BOARD OF COMMISSIONERS OF THE PORT OF NEW ORLEANS
NOTE TO PERSPECTIVE BIDDERS
CONTRACT FOR
FRANCE ROAD TERMINAL AND JOURDAN ROAD
REPAIRS TO PUMP STATIONS P2-P5 AND
PATTERSON PUMP STATION
DAMAGE BY HURRICANES KATRINA AND GUSTAV

August 1, 2011

ADDENDUM NO. 3

PLAN OF P-3
SCALE: 3/8" = 1'-0"

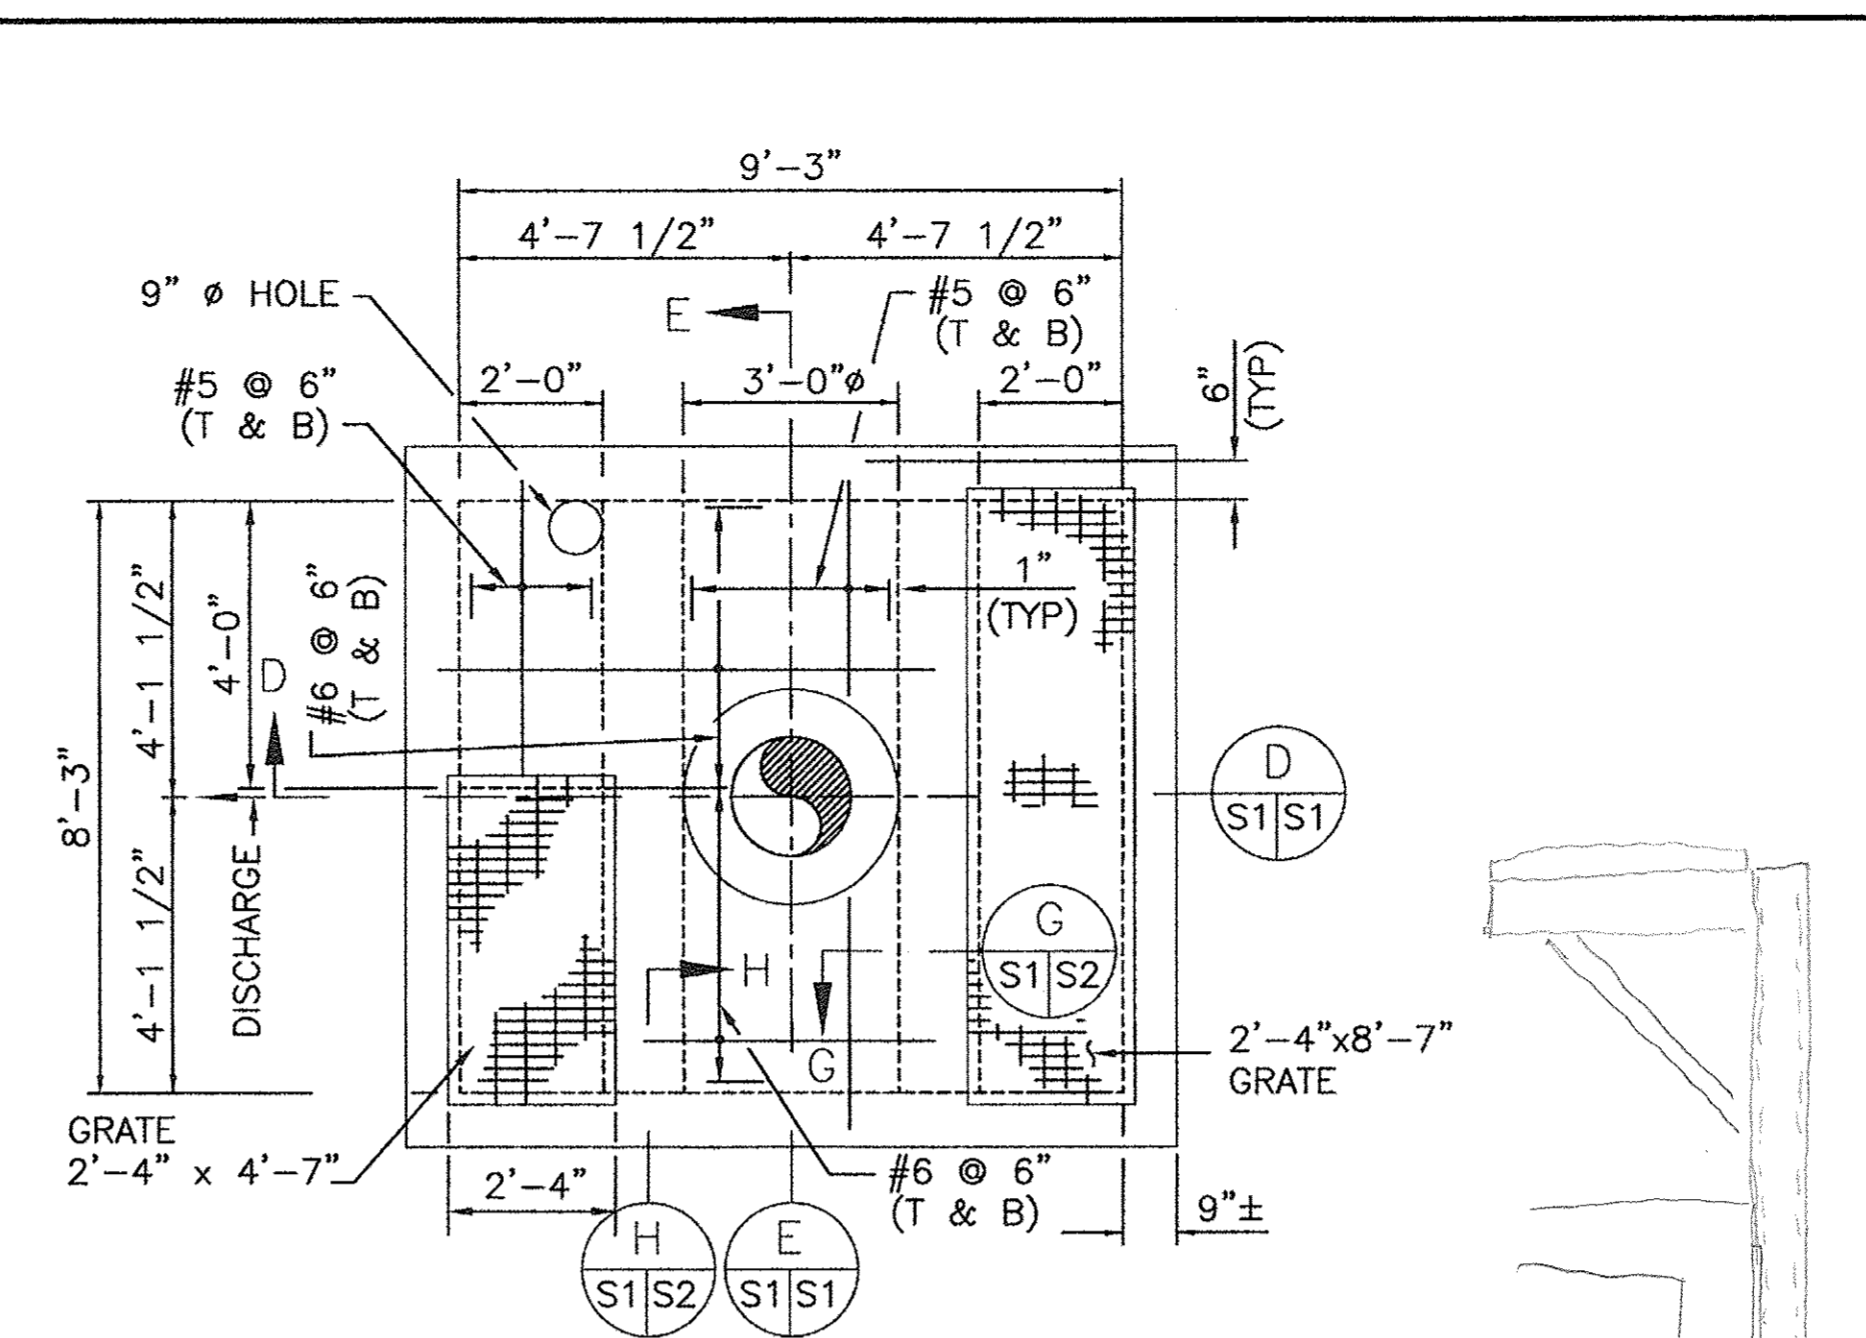
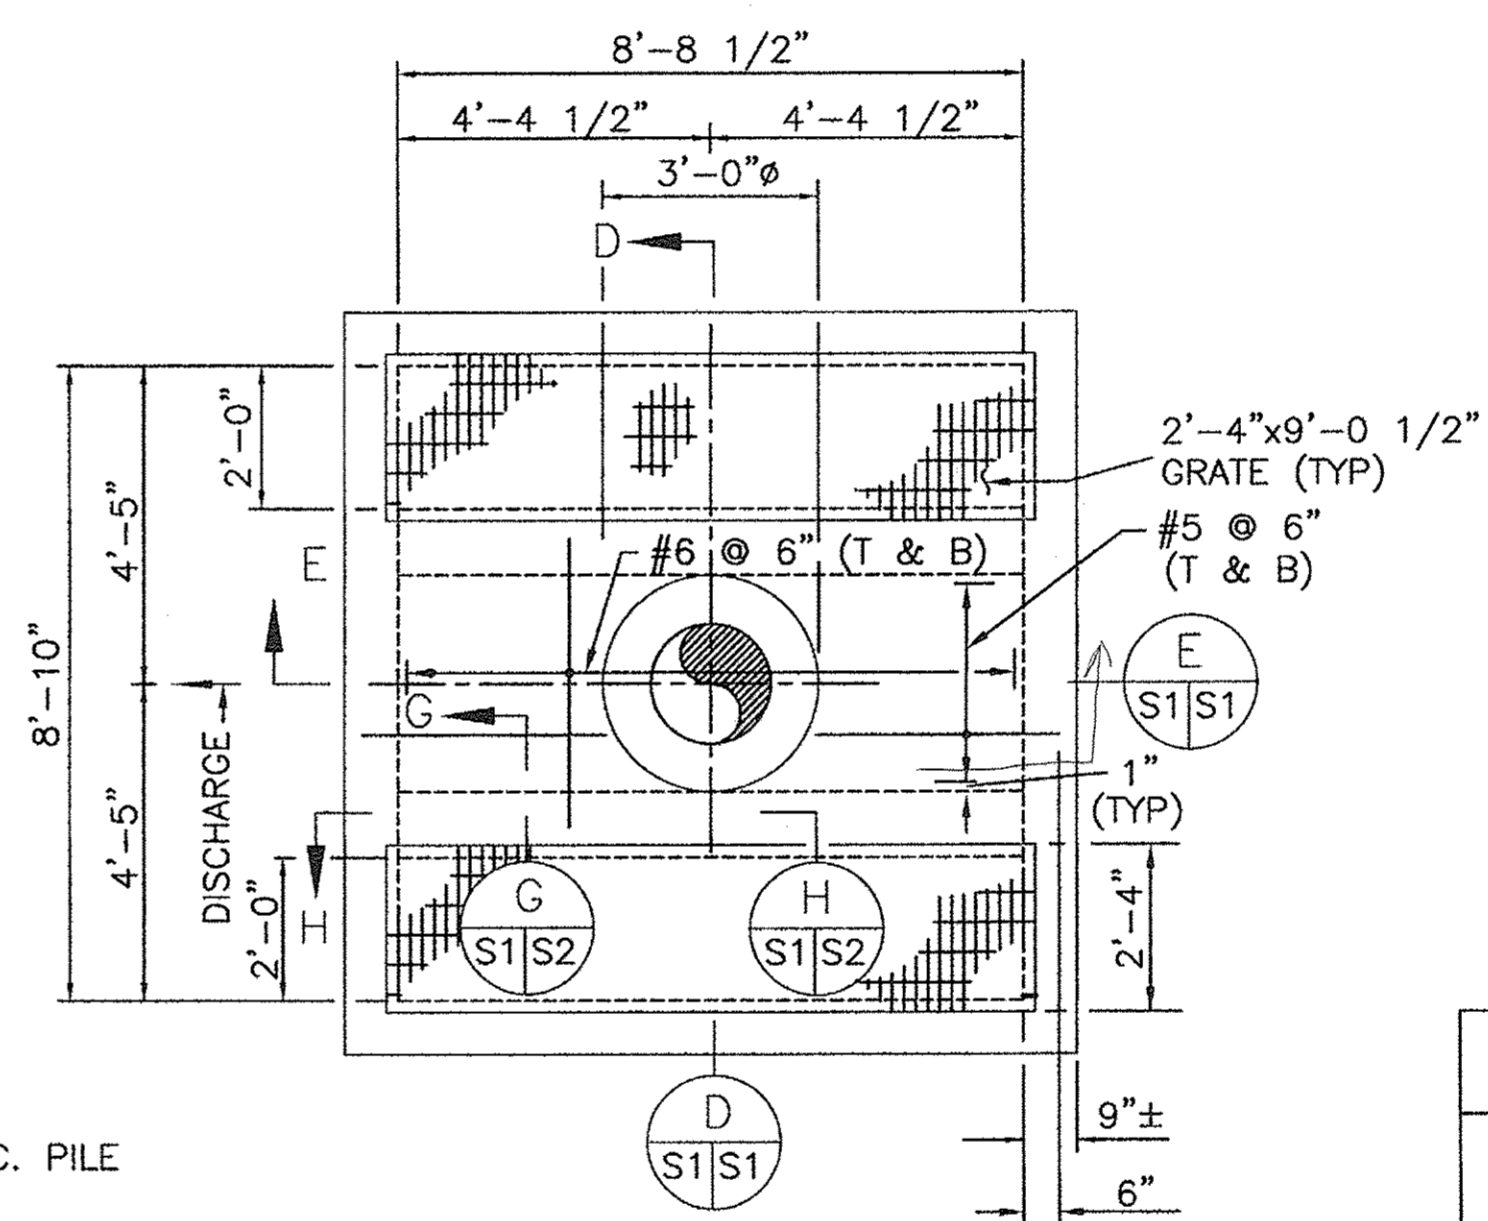
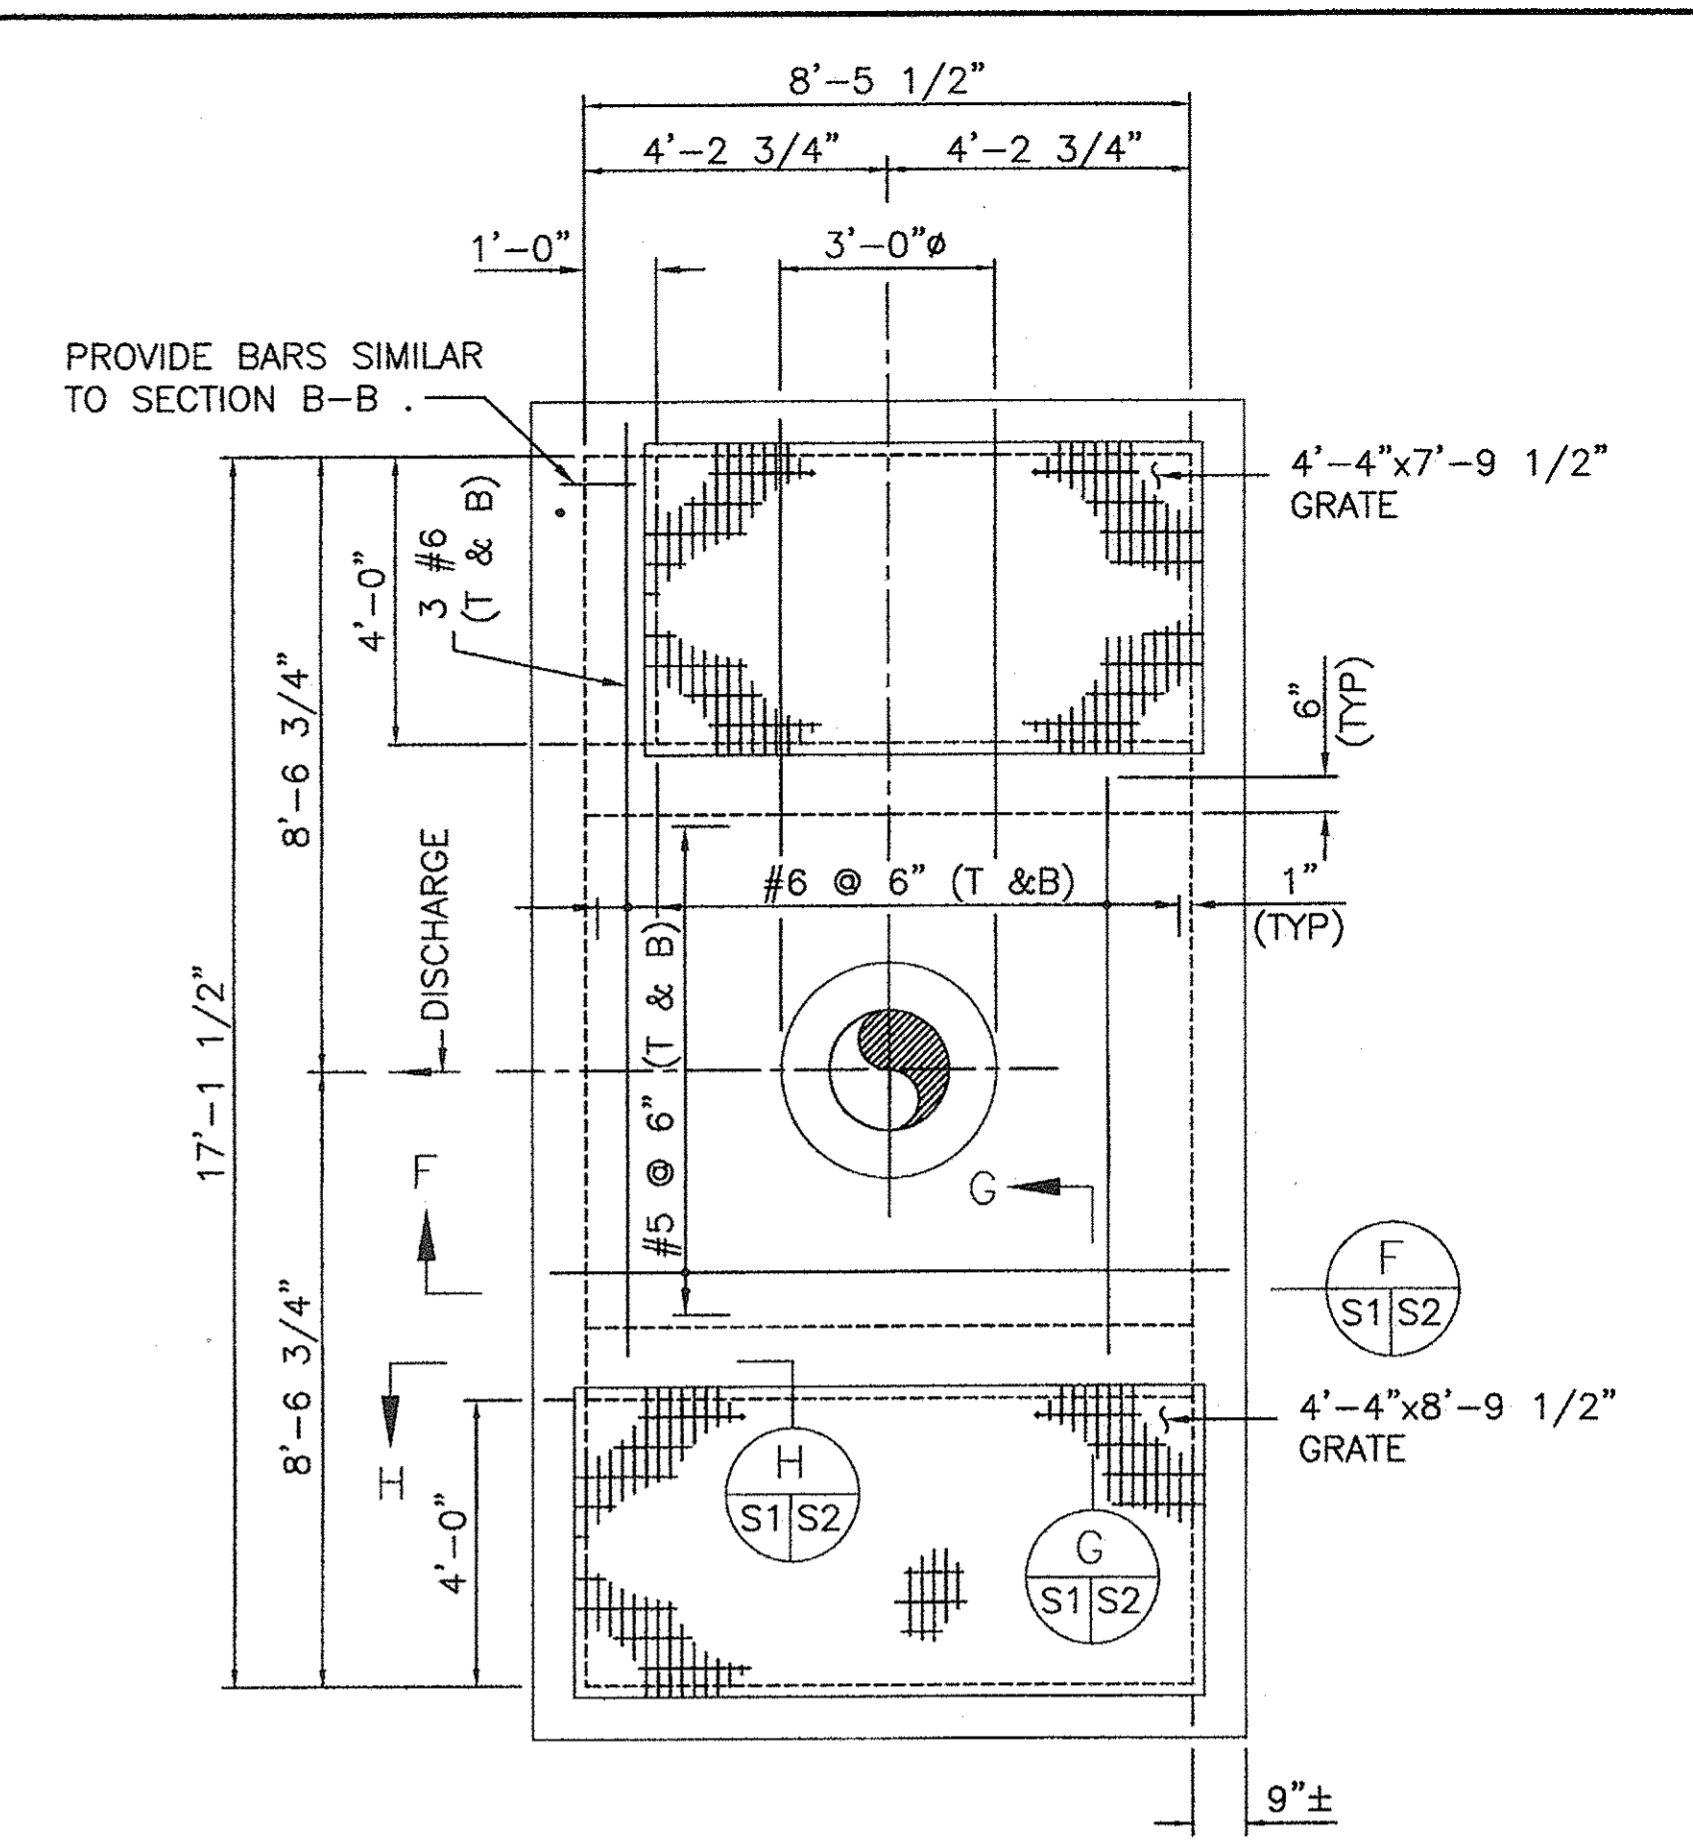
Q9: The existing pumps must be removed from their present location and re-installed with new anchors through the base plate. Grouting of the base plates is required. Please provide drawings of the existing concrete structure, including the size of the pump penetration, so that we may determine the area of the grout and the space available for drilling new anchors as shown on the project drawings.

Drawing M11-7038-S1 is being issued with this Addendum No. 3 for information only. This drawing shows the layout of the wet well and pump housing attachment.

Answer: We are including a drawing showing the existing concrete structures as part of this Addendum. See Item 24 below.
